**Final BART Determination Report  
Golden Valley Electric Association (GVEA)  
Best Available Retrofit Technology (BART) Evaluation**

State of Alaska  
Department of Environmental Conservation  
Division of Air Quality

Enviroplan Consulting Project No. 209928.15  
January 19, 2010  
**Revised June 1, 2010**

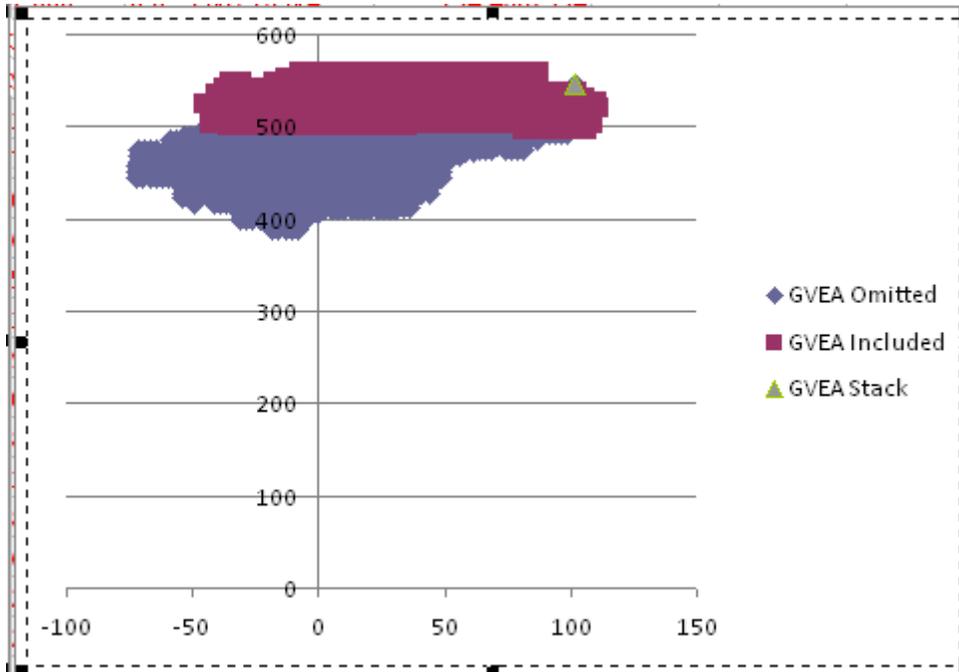
In accordance with the Department's March 17, 2010 email request on the above referenced project, Enviroplan Consulting conducted a visibility impact modeling assessment of the GVEA Healy Power Plant Auxiliary #1 Boiler. The purpose of this analysis is to determine whether the existing Auxiliary Boiler #1, as a BART eligible unit, exceeds the 0.5 deciview visibility significance metric when the unit is modeled with correct NO<sub>x</sub>/SO<sub>2</sub> emission rates.

Based on the information described above, Enviroplan determined the revised maximum visibility impact (daily delta deciview, dv) attributable to Auxiliary #1 Boiler. The following presents a comparative summary of the Auxiliary #1 Boiler visibility prediction results:

Auxiliary #1 Boiler Modeled Scenario	Maximum Predicted Visibility Change (Daily Delta-Deciview) (dv)	Significant Change in Visibility* (dv)
GVEA Calpuff Analysis	0.067	0.5
Enviroplan Revised Calpuff Analysis	0.158	0.5
